CANDLEWOOD SUITE HOTEL | CHERRY HILL SWEDISH CAMPUS

PLAN CHANGES FROM 09-11-2019 SAC MEETING - HOTEL PROPOSAL

505 16TH AVE, SEATTLE

L5 - L6 FLOOR PLANS - PROPOSED

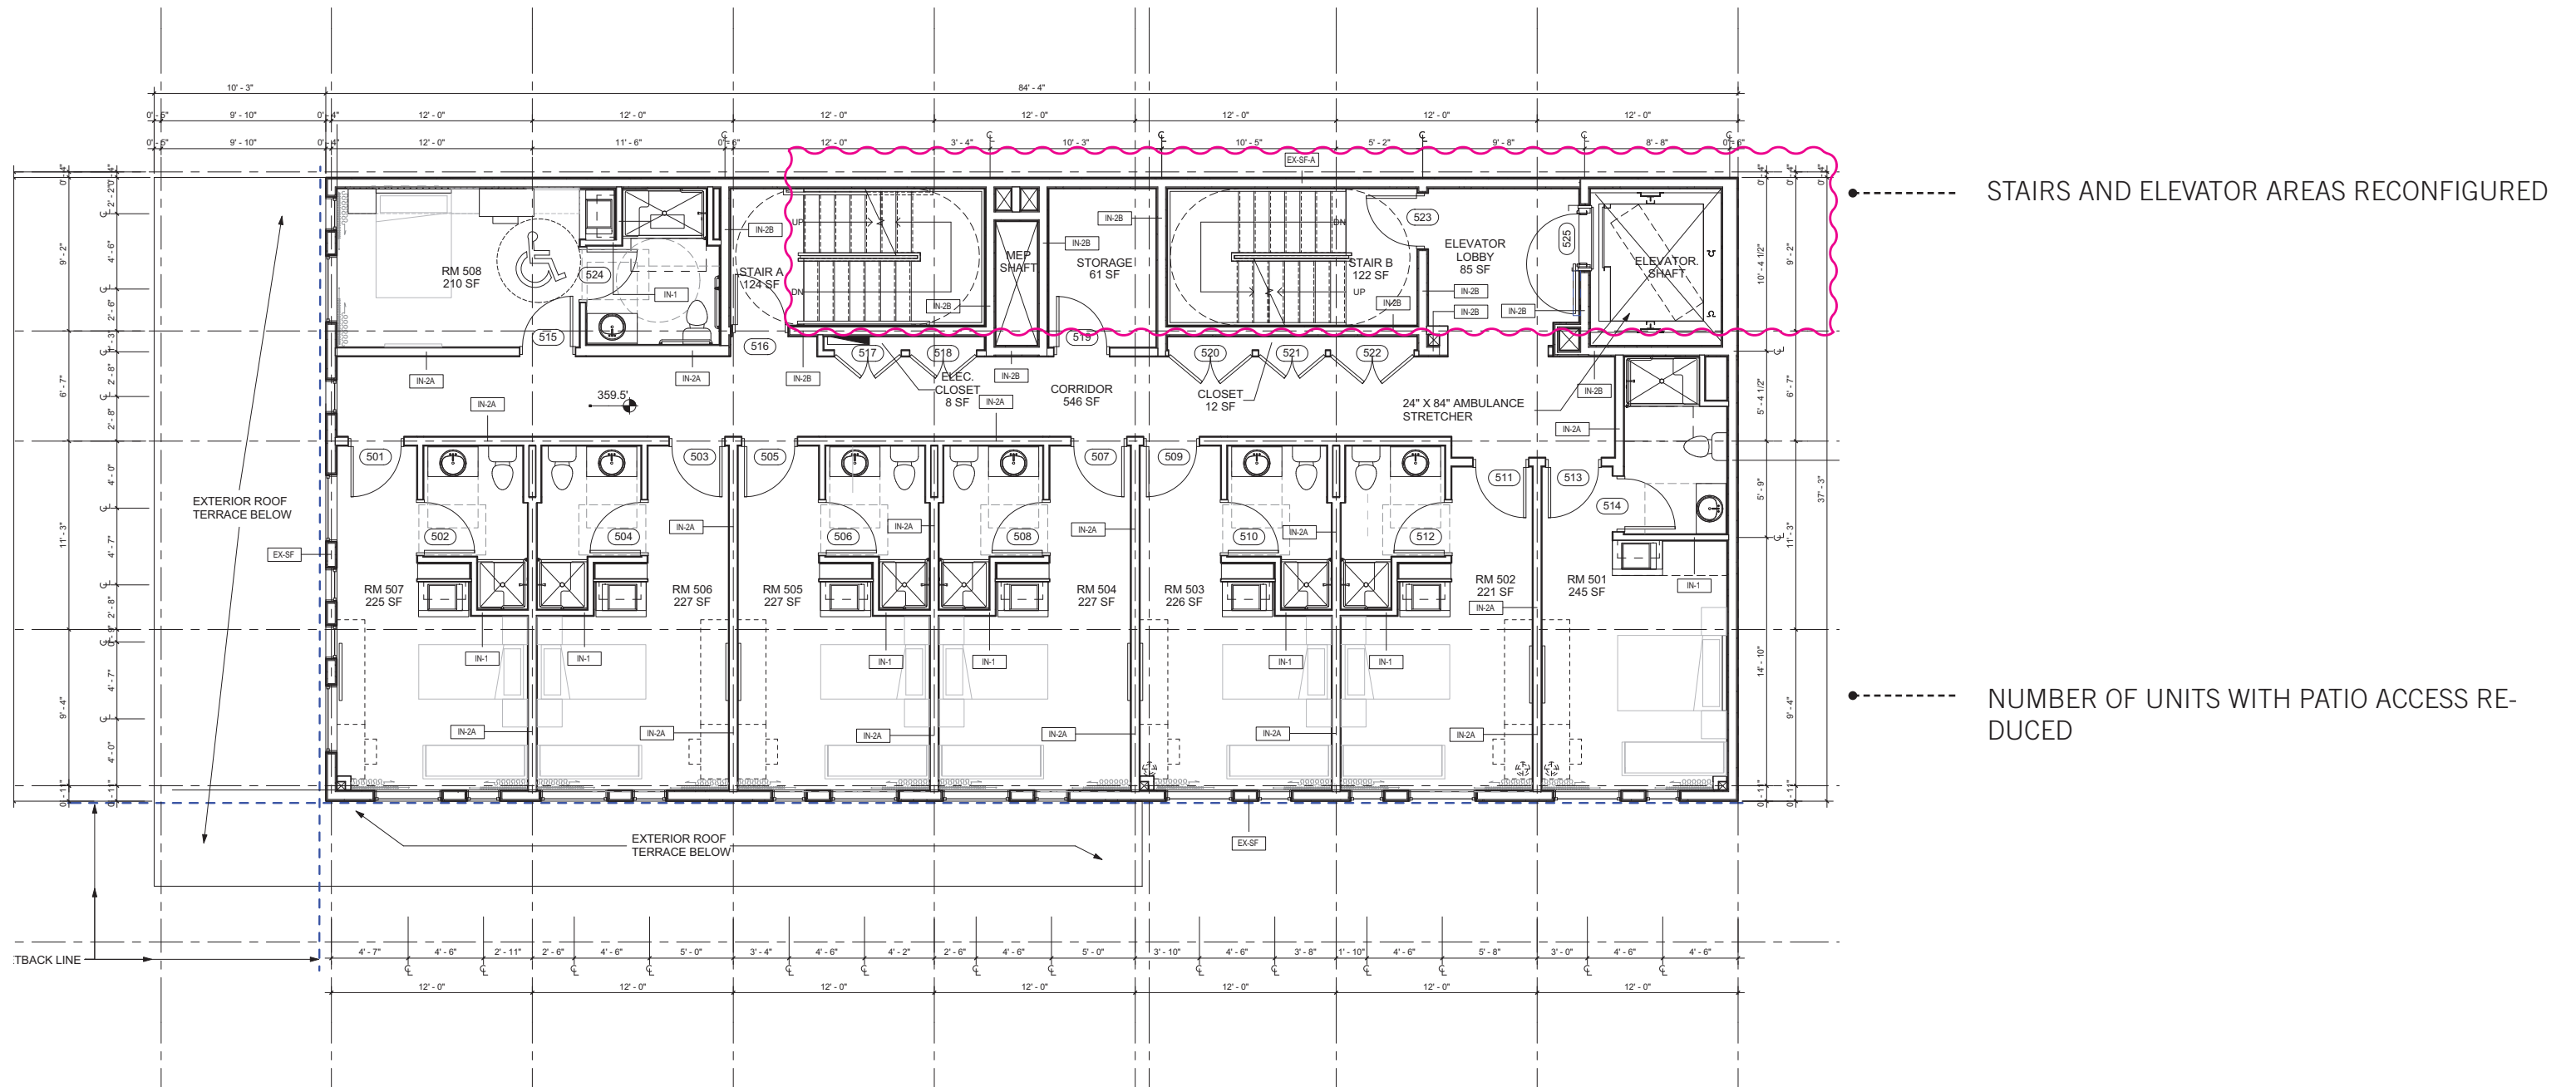
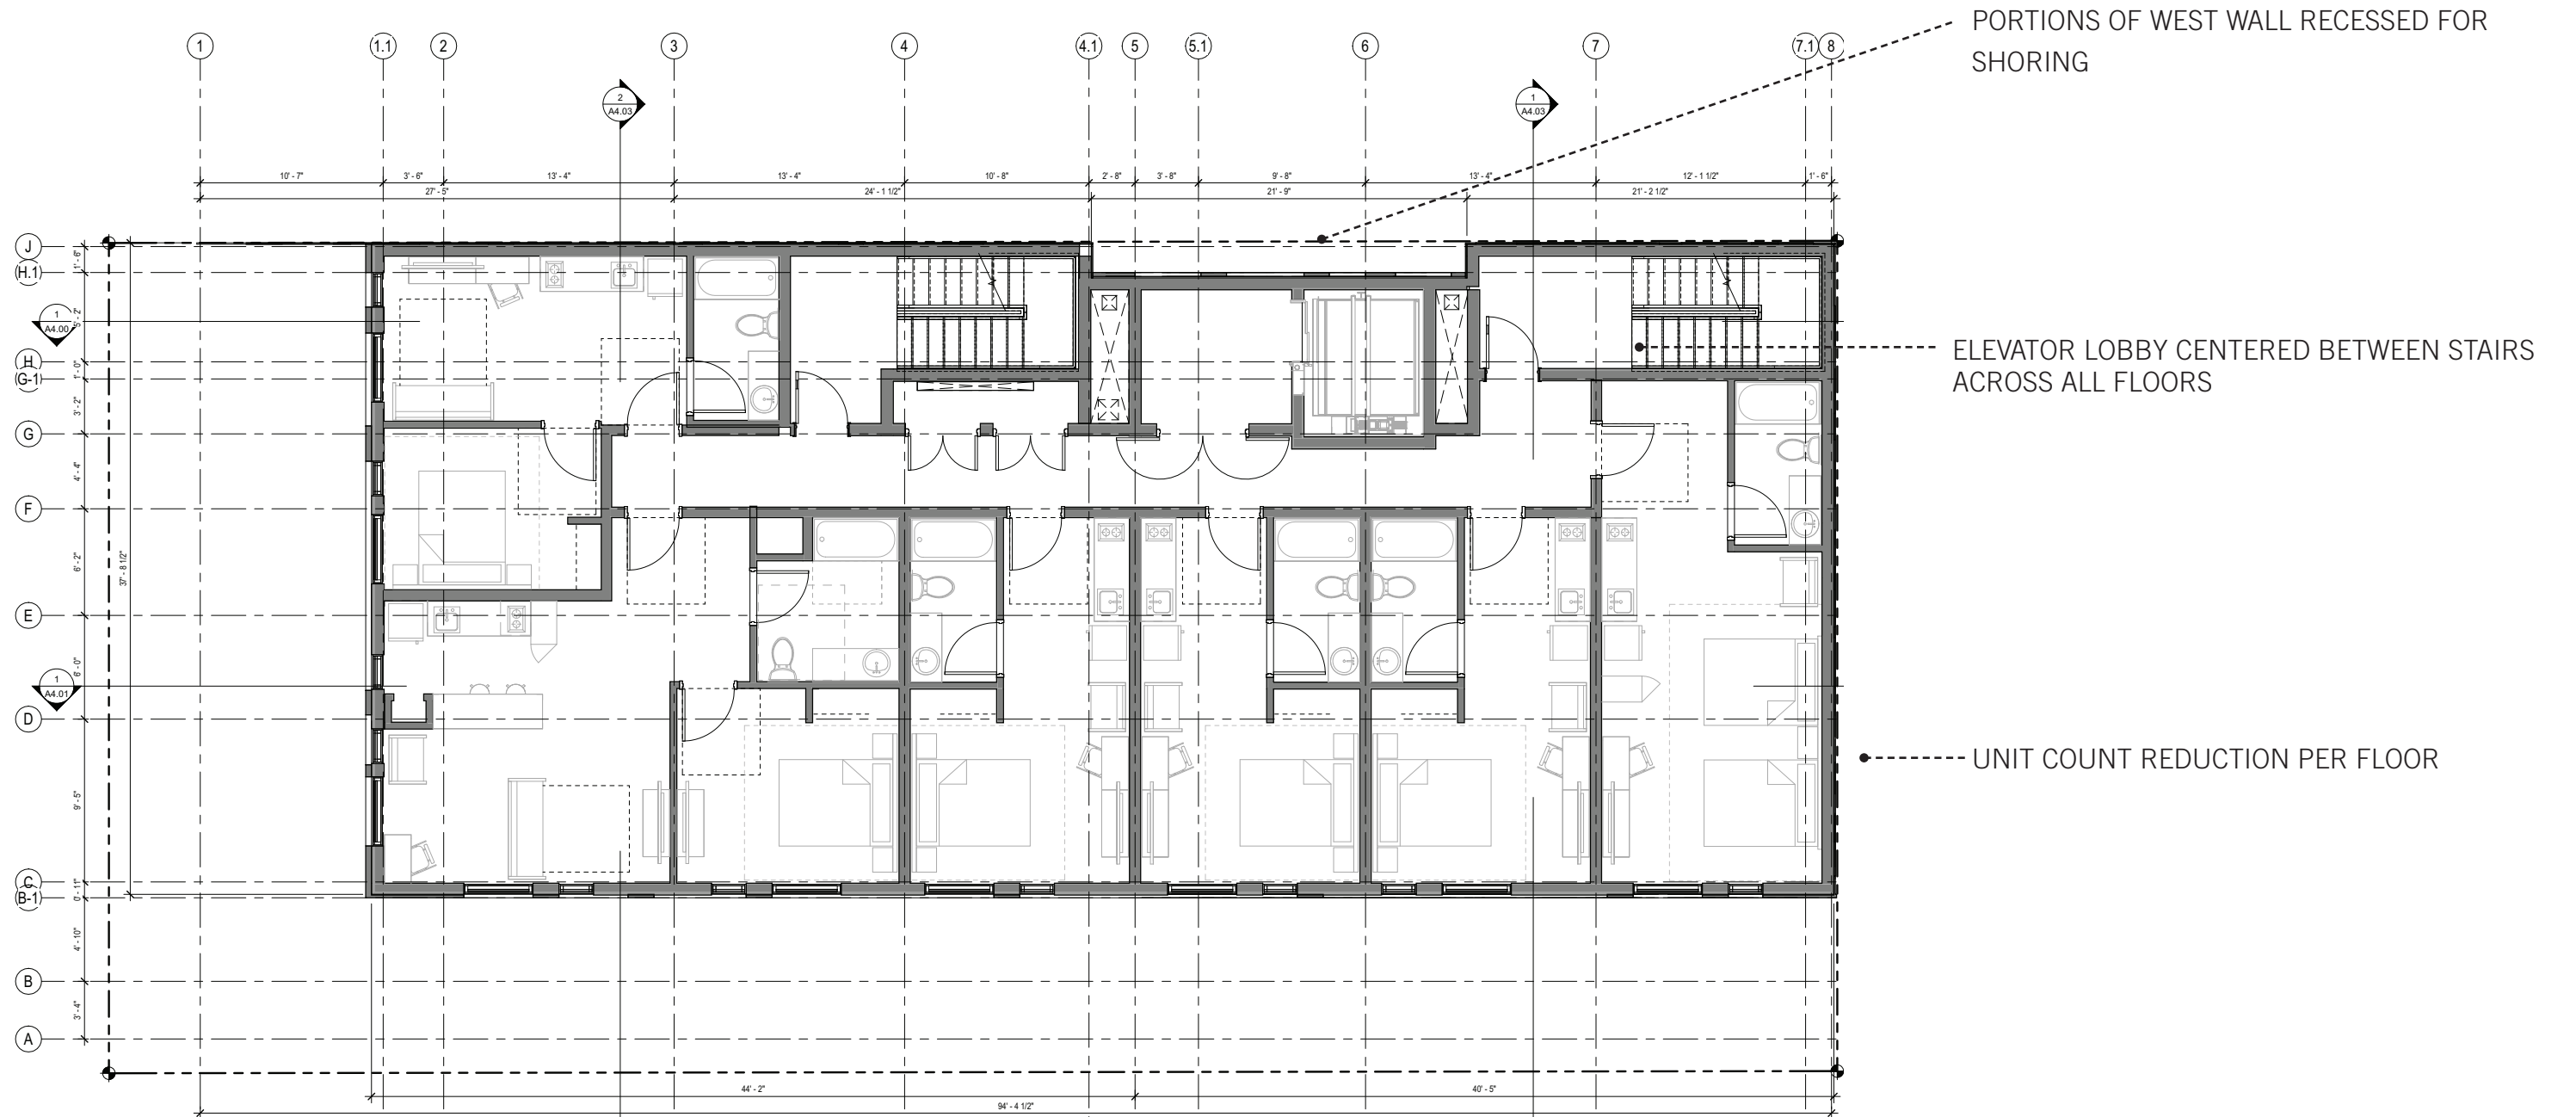
PORTIONS OF WEST WALL RECESSED FOR SHORING

ELEVATOR LOBBY CENTERED BETWEEN STAIRS ACROSS ALL FLOORS

UNIT COUNT REDUCTION PER FLOOR

ROOFTOP FLOOR PLAN - PROPOSED

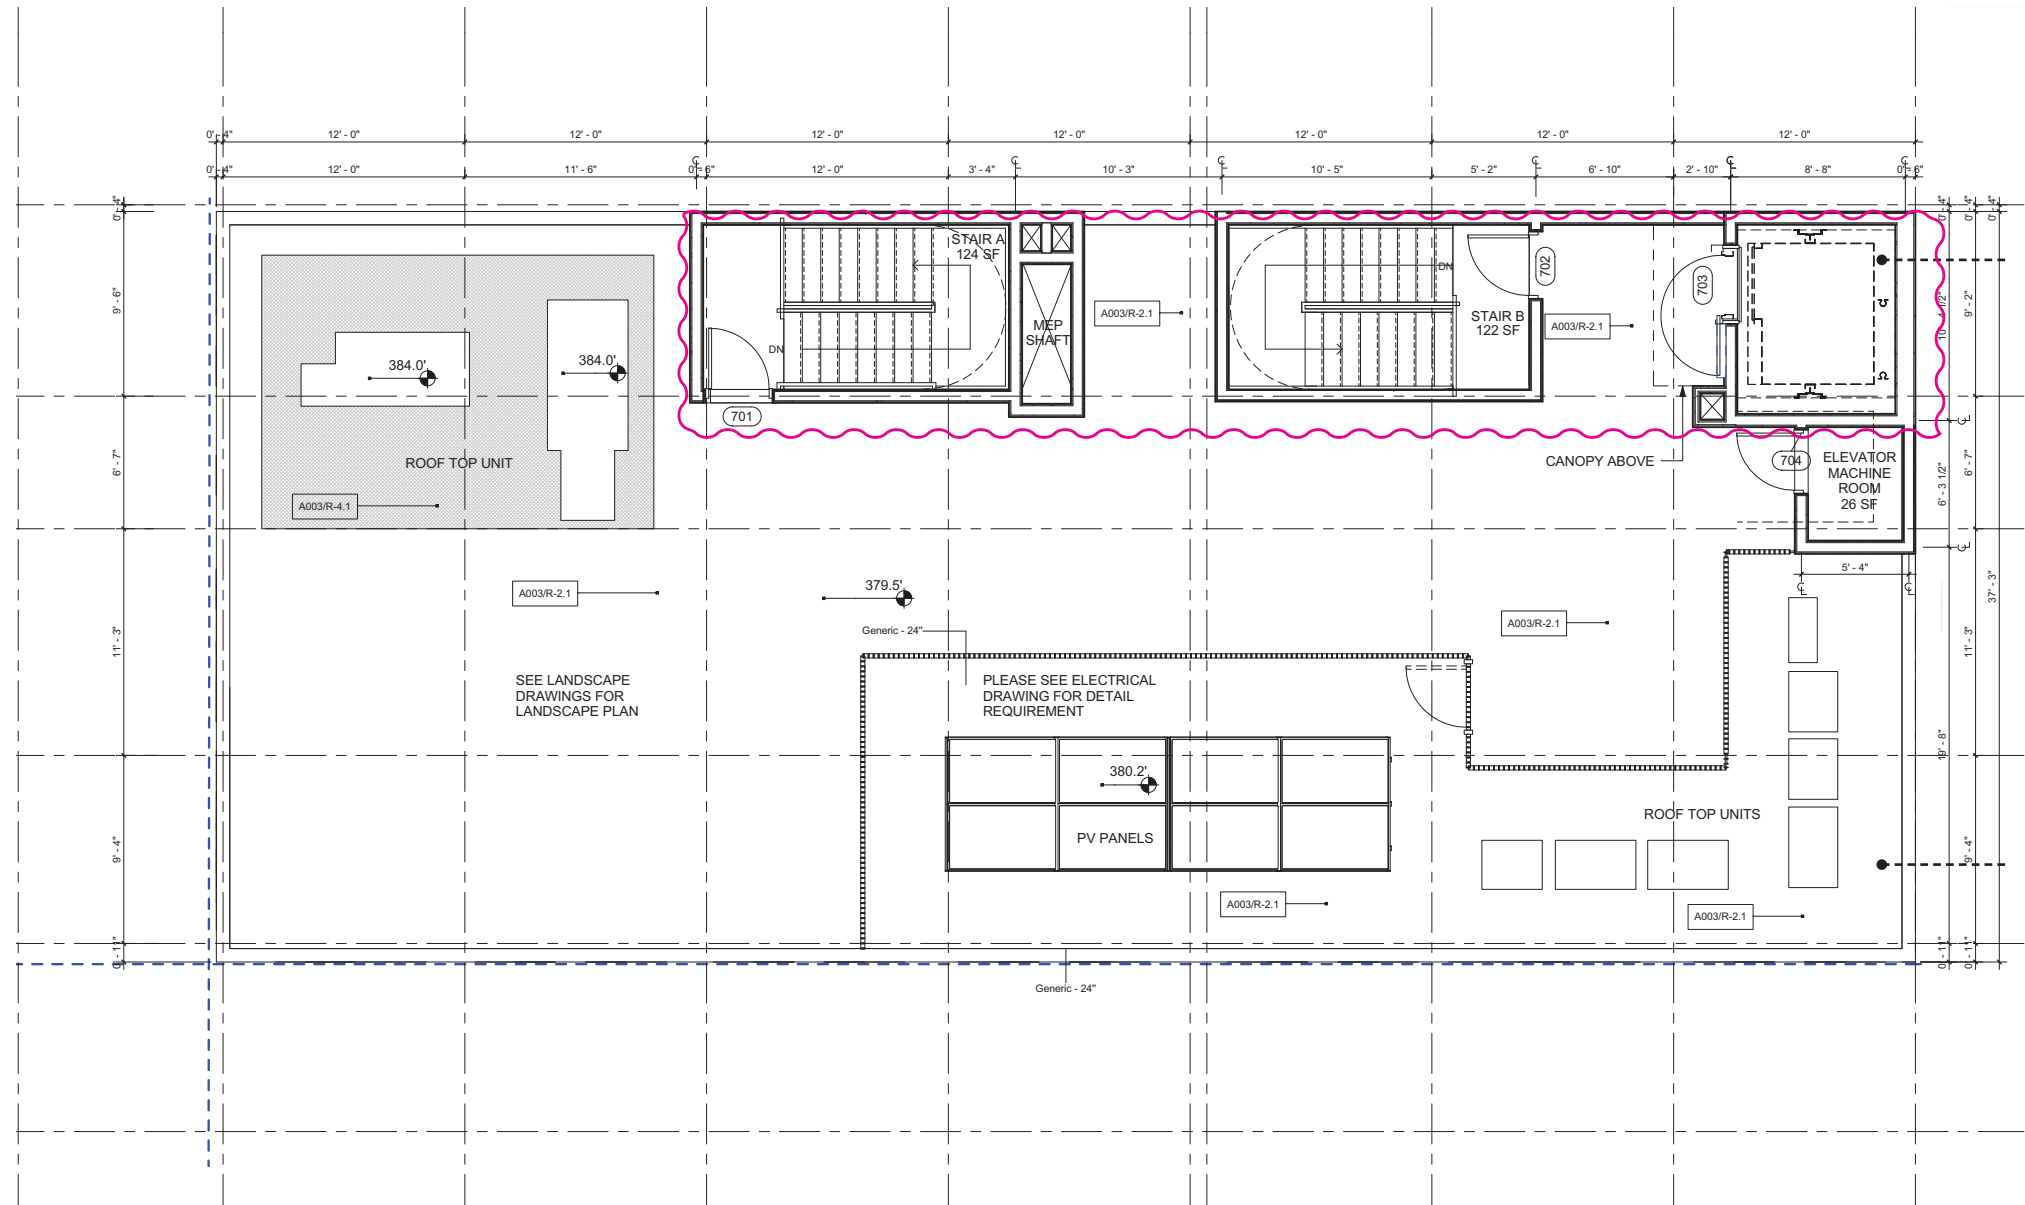
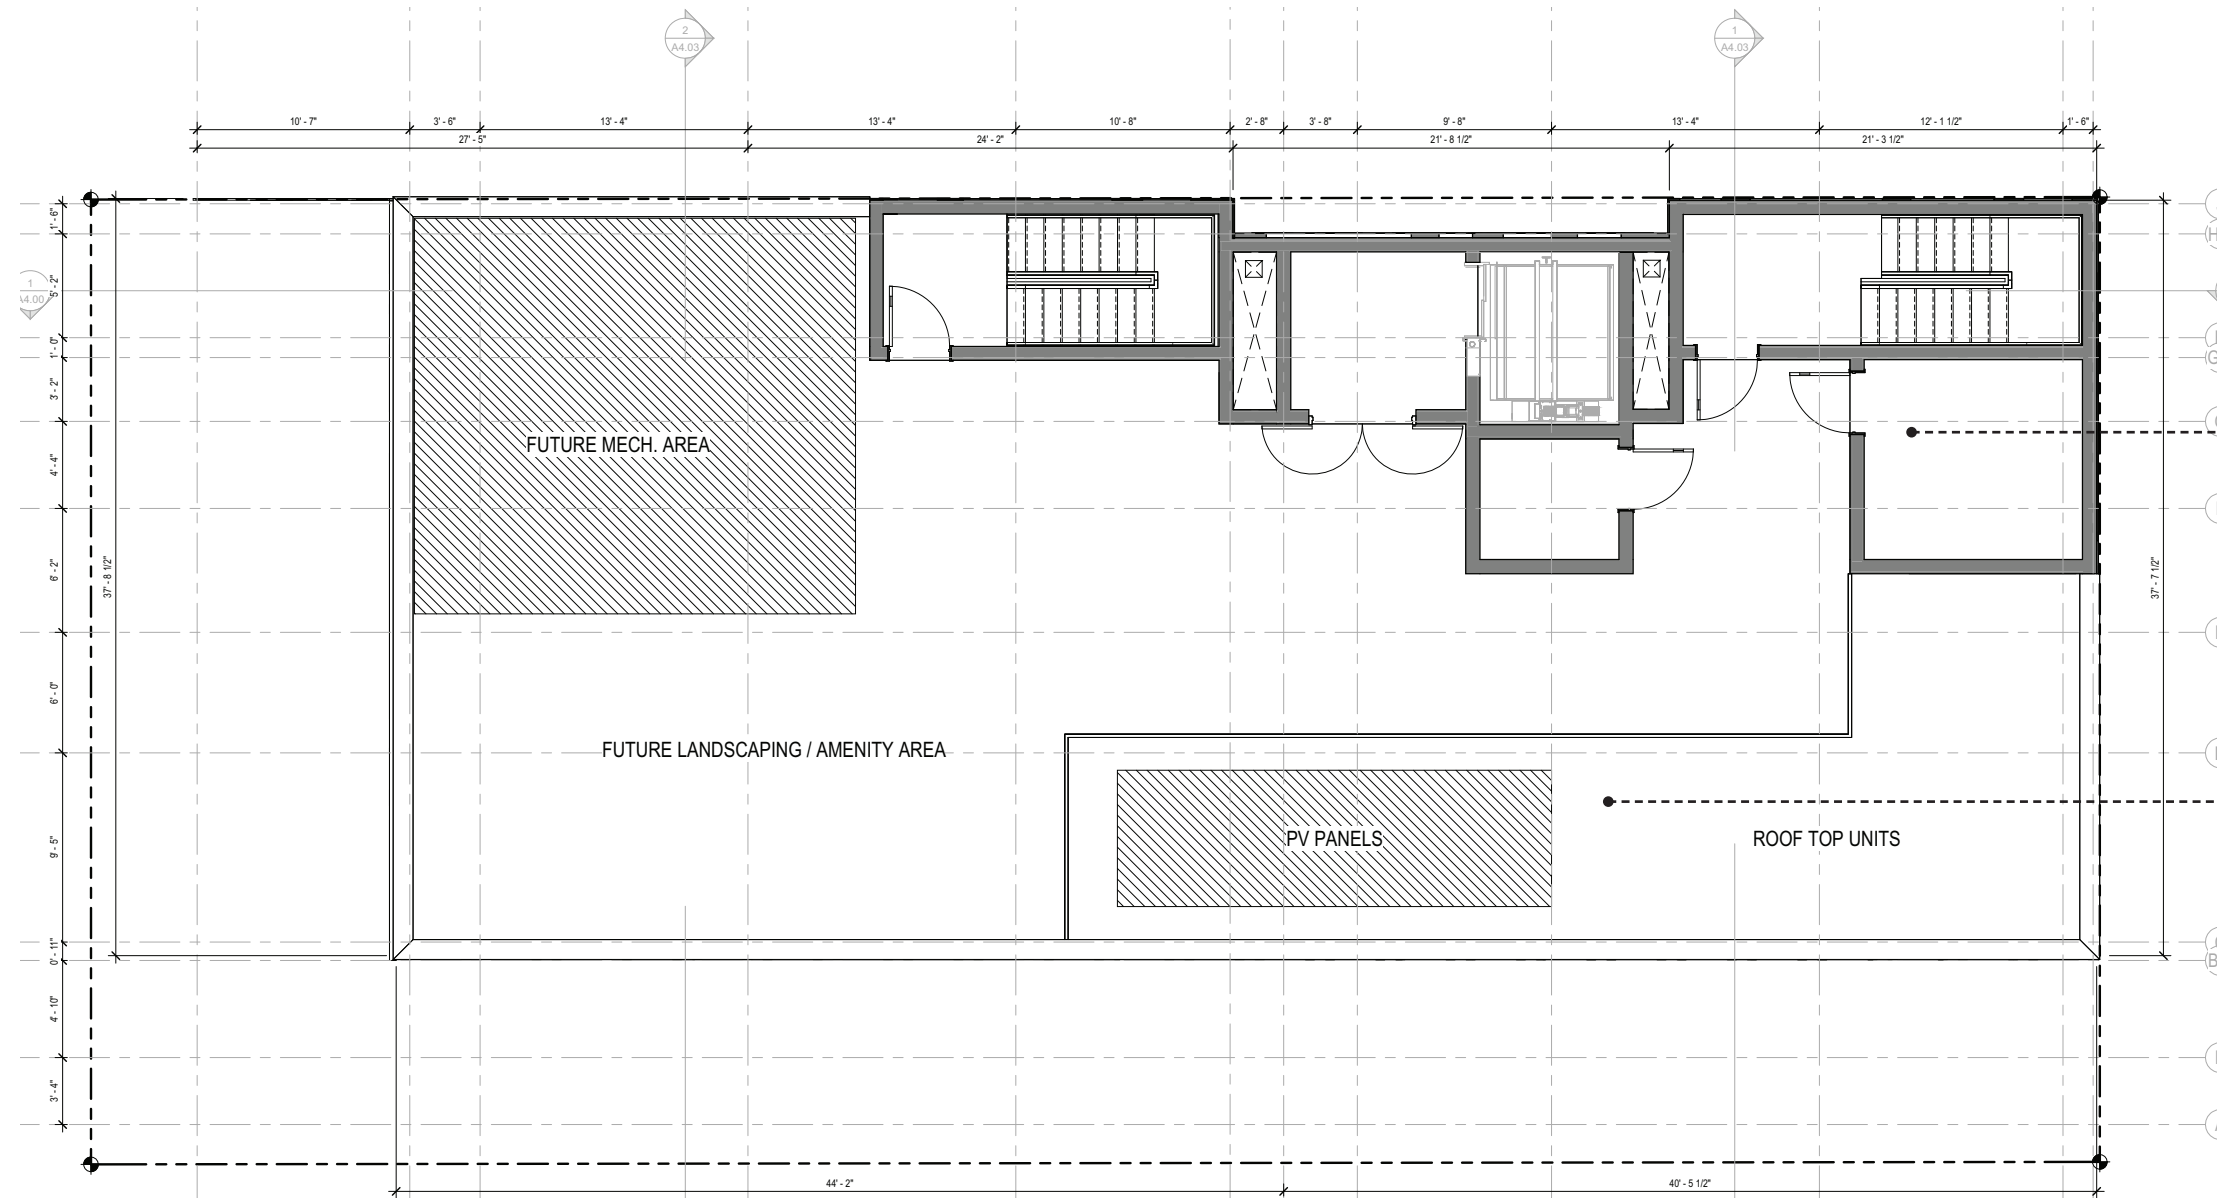
STAIRS AND ELEVATOR AREAS RECONFIGURED

NUMBER OF UNITS WITH PATIO ACCESS REDUCED

STAIRS AND ELEVATOR LOCATIONS ADJUSTED TO MATCH CONFIGURATION AT LEVEL BELOW

ROOF TOP AMENITY AREA TO REMAIN AS ORIGINALLY PROPOSED
